Regarding: Comments on proposed 525 Holly Ave ADU design

# **Context for Concerns on Submitted ADU Design**

Fig. 3. Former treed area on alley and 525

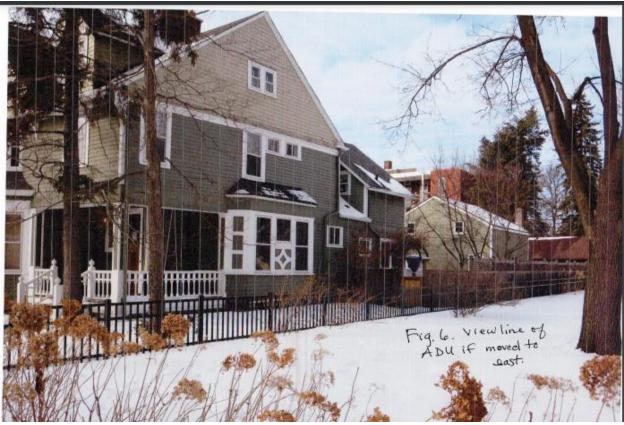
Some Ashland Avenue neighbors in the 6-unit condominium across the historic alley are concerned that the ADU extension proposed to the 525's northwest corner will **remove the undeveloped extreme northwest corner of 525 Holly** (Fig. 3). This undeveloped area adjacent to and slightly over the historic alley line is approximately 140 square feet. This is the only larger place where snow removers can deposit snow (Fig. 4, March 1) when clearing neighbors' garage aprons and stretch of alleyway (Fig. 5) adjacent to and directly across from the new ADU so that the 528 Ashland and 529 Holly neighbors can get their vehicles safely out in winter with snow and ice.

Figure 8 – separate page

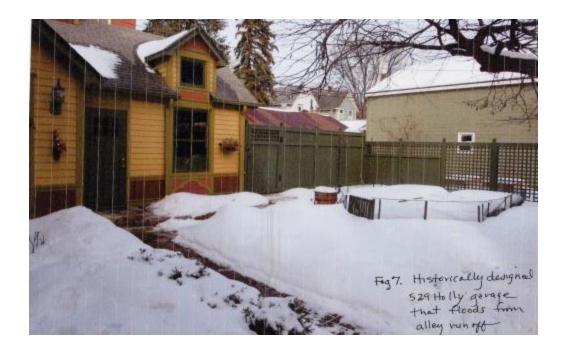
- 1. Given that there is no private property on the east side of 525 Holly Ave, the building mass impact of the proposed design would be mitigated if the ADU, with its increased footprint, is extended eastward, not westward that results in boxing in the northeast corner and garden area of 529 Holly Ave. An additional benefit for the ADU occupant of extending eastward would be better back yard and street views (Fig. 6) than if the ADU extended westward with its short, fenced back yard views (Fig. 8 shows an approximated closed backyard view).
